May 28, 2021

Re: Response to Pleasant Prairie Solar Township Board of Trustees public meeting

To: Josh Hreha, Project manager, Invenergy
From: Darby Creek Association and Columbus Audubon
Subject: Communication regarding proposed Pleasant Prairie Solar Project
Date: January 26, 2021

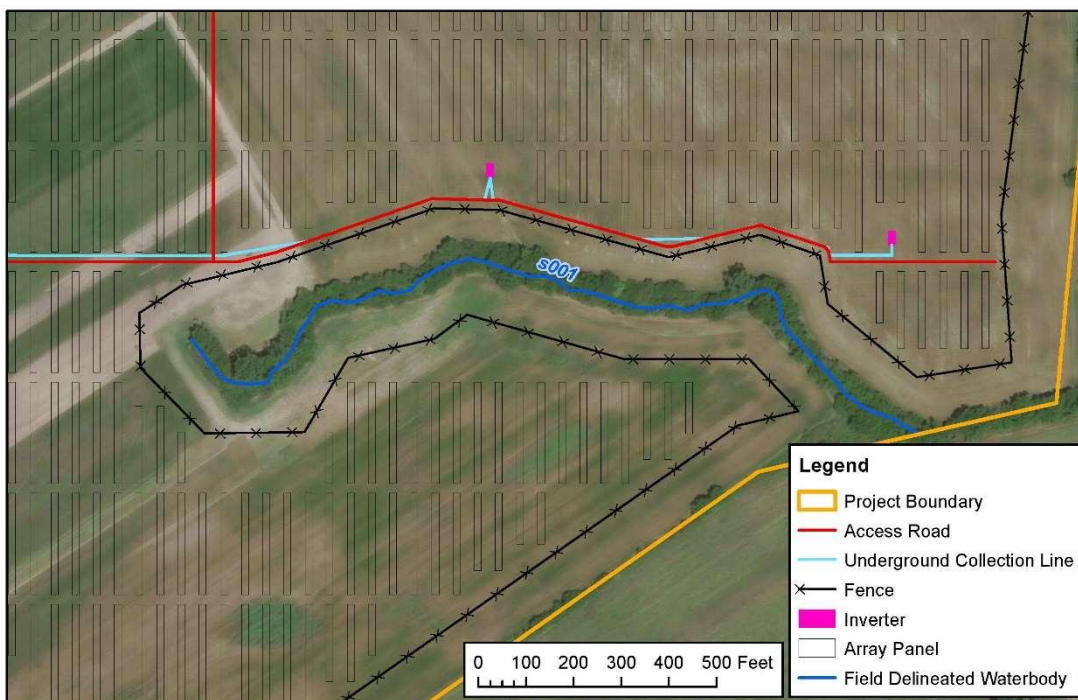
- 1) Wetlands: The facility should ensure adequate protection of wetlands, starting with a complete and proper Inventory and delineation of all wetlands, including temporary wetlands (Category I), and adequately protective buffers, adequate protection of wetland hydrology, preservation and enhancement of wetland wildlife, and connection to conservation land. We understand that as part of Clean Water Act obligations the facility will need to produce wetland identification, delineations and wetland scoring for the Army Corps of Engineers and Ohio EPA. We expect to have other protection points to follow. We expect that wetland impacts will be avoided to the greatest extent practicable, and that significant wetland enhancement might be possible, especially given the proximity to Battelle-Darby Metro Park.

As part of our site evaluation, the Project team conducted a detailed survey of surface waters (wetland and waterbody delineations) within the Project Area in fall of 2020. This Report was provided as part of our Application to OPSB, see Exhibit C - part 5 of 25.

This report provides details on delineated features including their scoring on the ORAM or HHEI/QHEI assessment forms. A total of 15 wetlands and one pond were delineated during field surveys, for a total of 8.15 acres of wetlands within the Project Area. Eleven of these wetlands were categorized as emergent, three were categorized as forested, and one was categorized as shrub-scrub. One wetland (W-002) was categorized as potentially jurisdictional and scored as lower quality wetlands on the ORAM. No wetland crossings are proposed, and we anticipate no impacts to wetlands from the construction or operation of the Project based on our current design.
